REMARKS

Amendments to the Drawings:

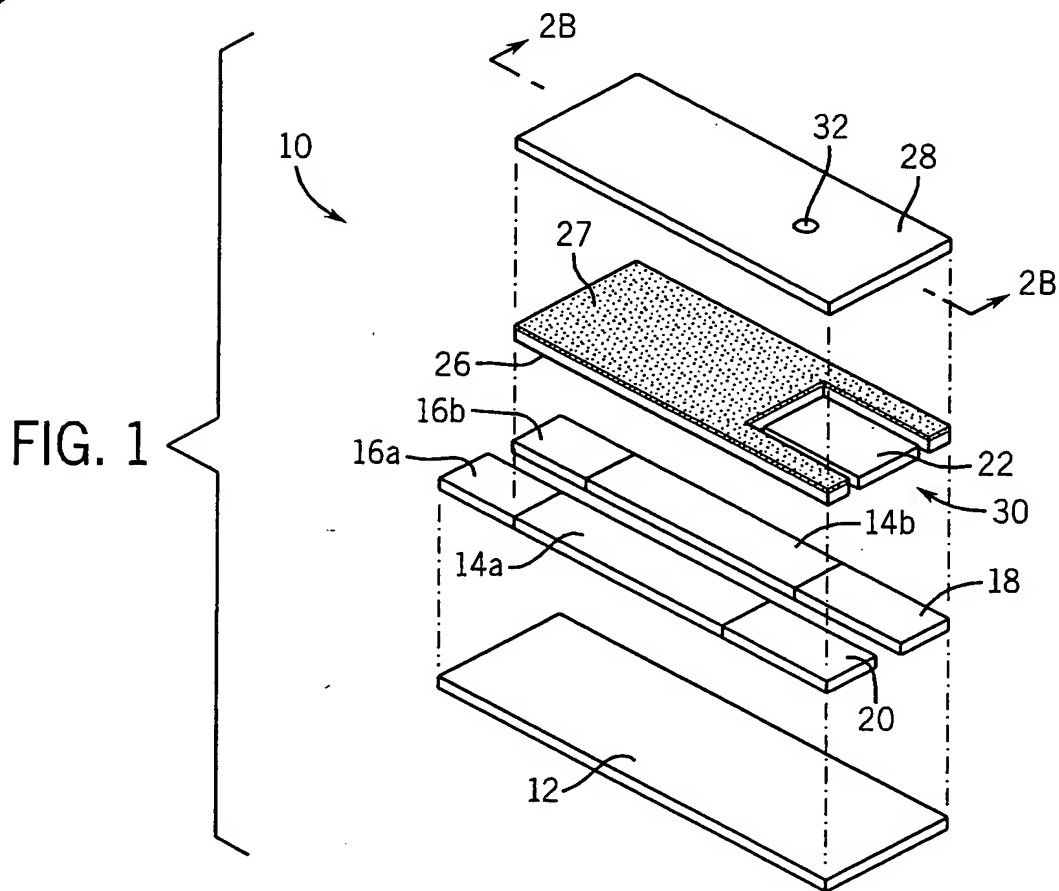
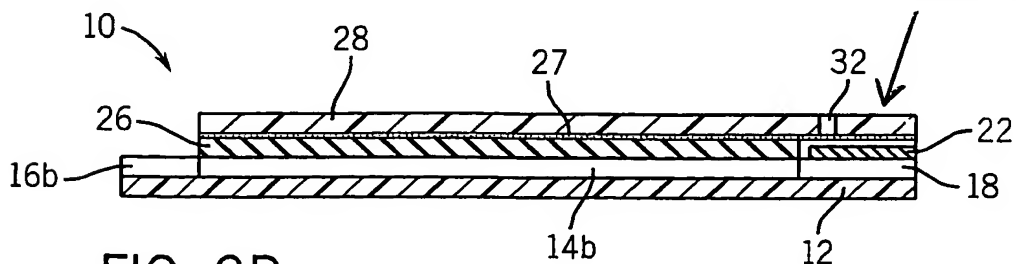
The attached sheets of drawings include deletion of FIG. 2 and substitution of FIG. 2 by FIG. 2A and FIG. 2B. In FIG. 2A and FIG. 2B, the capillary channel is shown more clearly by means of a dashed line in FIG. 2A and a section in FIG. 2B. The attached sheets of drawings include addition of FIG. 7 and FIG. 8. In FIG. 7, a trigger electrode 40 has been added, and the dual - purpose reference/counter electrode has been replaced by a separate reference electrode 36 and a separate counter electrode 34. The working electrode has been numbered as 38. In addition conductive tracks 14c, 14d, 14e, and 14f and electrical contacts 16c, 16d, 16e, and 16f have been added and numbered. In FIG. 8, a layer of mesh 40' has been added between the two substrates 12a' and 12b' and in the vicinity of the electrodes 18' and 20'.

Markings added to show
capillary flow channel

The drawings were objected to under 37 CFR 1.83(a). Corrected drawings are being submitted herewith. In addition, new drawings are also being submitted. FIG. 2 has been replaced by FIGS. 2A and 2B. These drawings clearly show the flow channel 30 is configured to provide flow of liquid by means of capillary attraction. FIG. 7, a new drawing, shows a biosensor having an electrode arrangement consisting of four electrodes, which both covers an electrode arrangement having both a reference electrode and a counter electrode and an electrode arrangement having a trigger electrode. FIG. 8, a new drawing, shows a biosensor having a layer of mesh for promoting flow of liquid to the electrodes.

→ FIG. 9

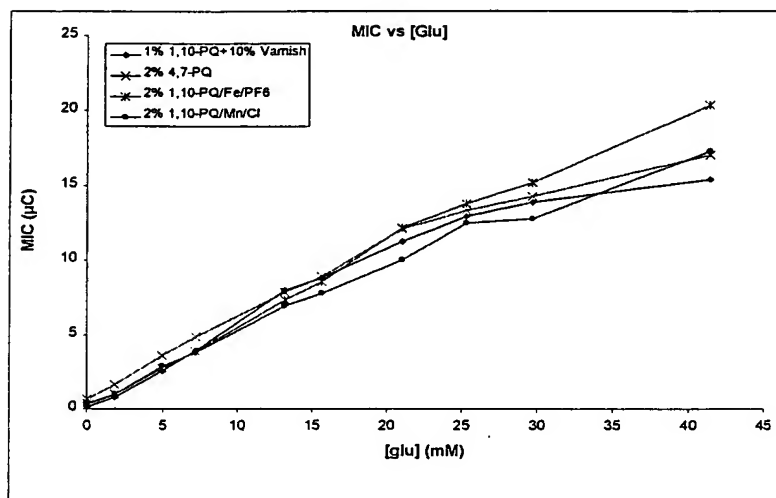
Renumbered figure
